Access Compliance Report Public Rights-of-Way (Curb Ramps)

Main Street: CASSELLE_AVE Cross Street: DUNAS_RD Location: SE

ADA ID: RPAT211005095248 Ramp Type: Type 1 - Perpendicular Diagonal Initial Pass/Fail: Pass Overall Compliance: No Severity Score: 26

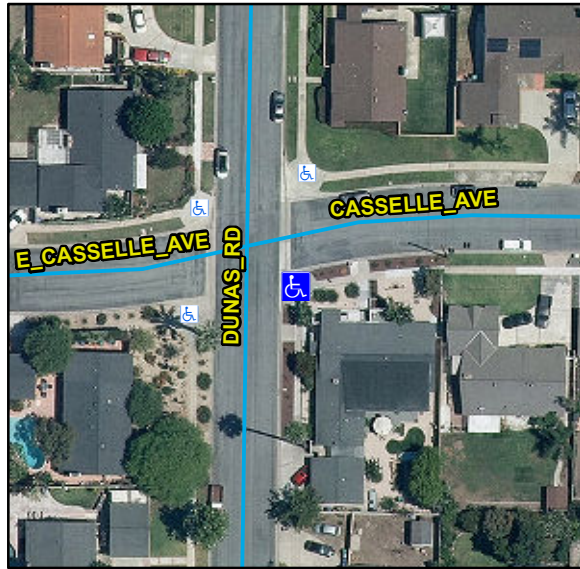
R304.2.2, R204.3, R304.5.3, R304.2.1, R304.2.2-Perp, R304.3.2-Para, R305, R304.5.4, STD 1115

Compliance	Description	Data	Compliance	Description	Data
N/A	Ramp Length (in)	128	N/A	Flare Type LT	
Yes	Ramp Width (in)	51			Sloped
Yes	Ramp Run Slope (%)	7.1	N/A	Flare Slope LT (%)	10.4
No	Ramp Cross Slope (%)	4.9	N/A	Flare Traversable LT	No
N/A	Landing Present	No	N/A	Flare Type RT	
N/A	Landing Length (in)	N/A			Sloped
No	Landing Width (in)	N/A	N/A	Flare Slope RT (%)	1.3
No	Landing Run Slope (%)	N/A	N/A	Flare Traversable RT	No
No	Landing Cross Slope (%)	N/A	No	DWS Provided	No
N/A	Landing Movement Obstructed?	Yes	N/A	DWS Contrast	N/A
	Landing Movement Type	Wall	N/A	DWS Length (in)	N/A
N/A	Landing Shared	N/A	N/A	DWS Full Width	N/A
N/A	Clear Space	Yes	N/A	DWS Offset Left (in)	N/A
N/A	Clear Space To Crosswalk (in)	48	N/A	DWS Offset Right (in)	N/A
N/A	Marked Crosswalk 1	No	N/A	Marked Crosswalk 2	No
	Crossing 1 Direction	N		Crossing 2 Direction	W
	Marked Crosswalk 1 Width (in)	N/A		Marked Crosswalk 2 Width (in)	N/A

N/A	Ramp Inside Crosswalk 1	N/A	Yes	Ramp Inside Crosswalk 2	N/A
	Crossing 1 Slope (%)	2.4		Crossing 2 Slope (%)	2.7
	Crossing 1 Cross Slope (%)	5.8		Crossing 2 Cross Slope (%)	1.2
Yes	Gutter Ponding	No	No	Curb Slope	8.6
Yes	Gutter Lip Height (in)	0		Road Run Slope (%)	2.7
No	Gutter Run Slope (%)	5.6		Road Cross Slope (%)	4.4
No	Gutter Cross Slope (%)	5.1			
Yes	Overall Surface Condition: Acceptable		No	Perp Joint Present	No
	Cross Gutter Present?	Yes		Spandrel Present?	Yes
	Replace Cross Gutter?	No		Replace Spandrel?	No

Remove & Replace Curb Ramp With Two New Directional Ramps or Equivalent. Remove & Replace Gutter.
